19-008

Subject: RECALL CAMPAIGN – Bentley Mulsanne Rear Seat Belt Anchorage Plate (RE19/01)

Topic	Mulsanne - Rear seat belt anchor plate installation (RE19/01)
Market area	Bentley: worldwide (2WBE),Hongkong-Macau (5HK)
Brand	Bentley
Transaction No.	2052868/1
Campaign number	RB15
Note	
Type	
US code

Figure 1

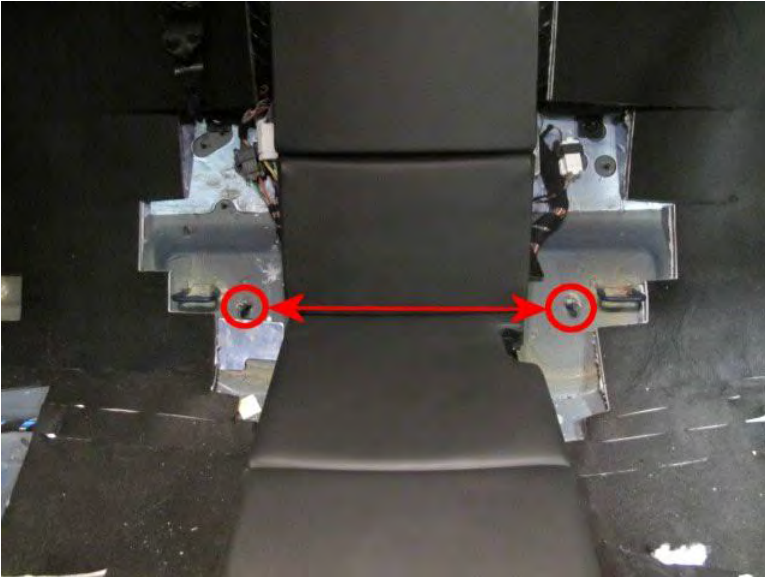
The right and left hand inner rear seat frame studs as shown in Figure 1 are located on opposing sides of the propshaft tunnel, the studs are used to locate and secure the rear seat frames, centre seat belt buckle and the seat belt anchor to the rear floor panel

Both studs require removal, once removed the installation of pre-assembled plates is required to the left and right hand side

The installation of left and right hand plates is required for remedy, the replacement seat frame studs are an integral part of the plates

Figure 20

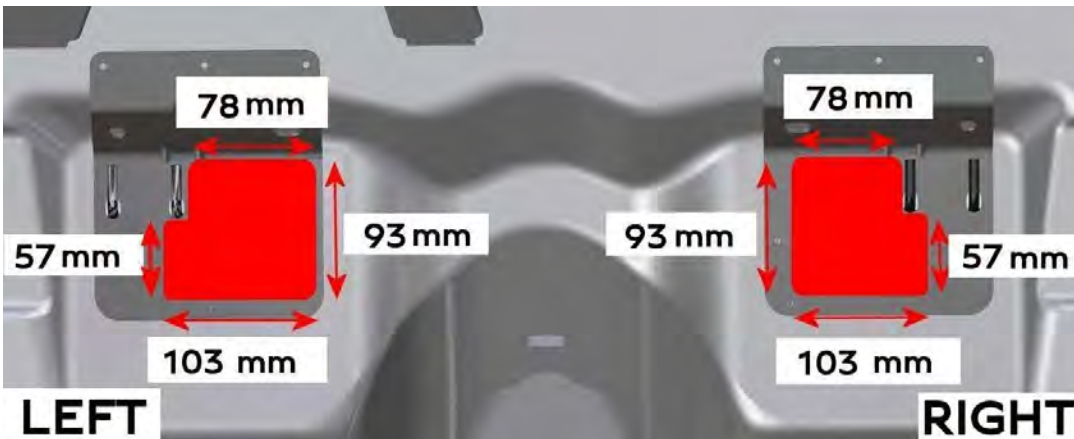
6) Referring to Figure 20 - Scrape/remove the underseal from the areas shown on the right and left hand side, once removed use fine grade sandpaper to remove any remaining underseal

It is imperative that the areas shown in Figure 20 are completely free of underseal as per the dimensions provided, should the operative **NOT** remove **ALL** underseal the fitting location of the plates in relation to the floor panel may be compromised

Figure 25

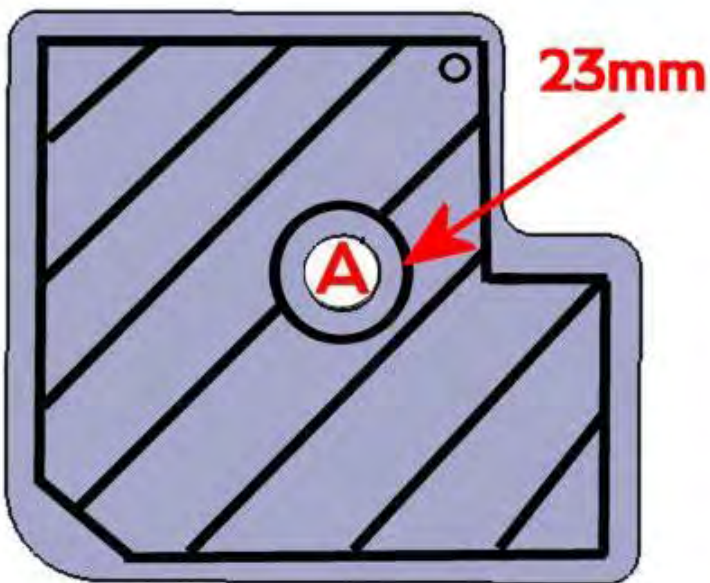
- Referring to Figure 25 apply in the pattern shown onto the inner mating face, ensure a ring of adhesive with a 23mm diameter is applied around the plate stud shown at Point A

Figure 27

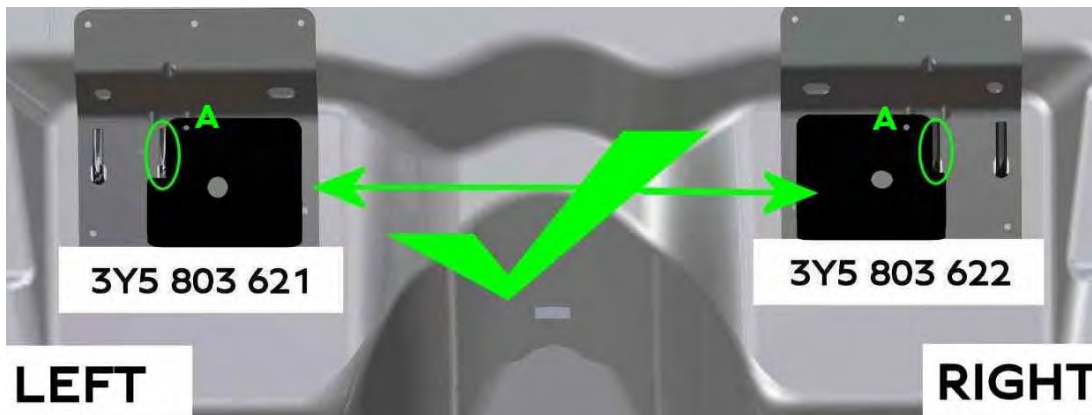
- Referring to Figure 27 - Ensure the plates are positioned exactly as shown, the isofix welds (Circled) should be used to locate and position the plates
The holes which are drilled through each plate (Point A) can also be used for confirmation regarding correct fitting location

Figure 32

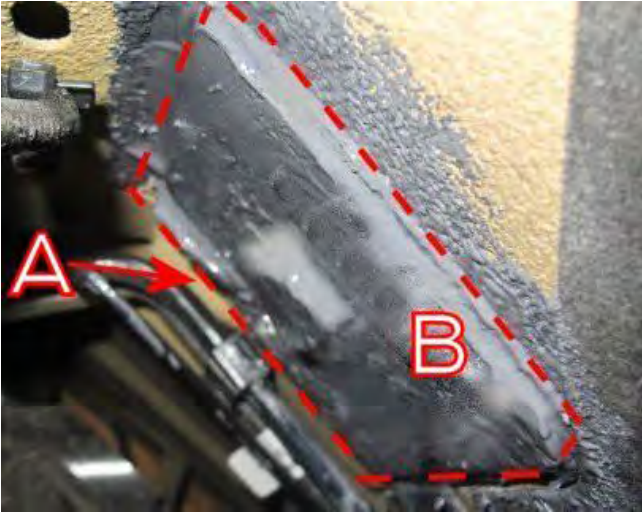
- Referring to Figure 32 - Manually apply the underseal to all four edges of the left hand plate (Point A) ensure the outer face of the plate is covered (Point B)
- Ensure all outer edges are backfilled from the plate onto the floor panel to create a watertight seal
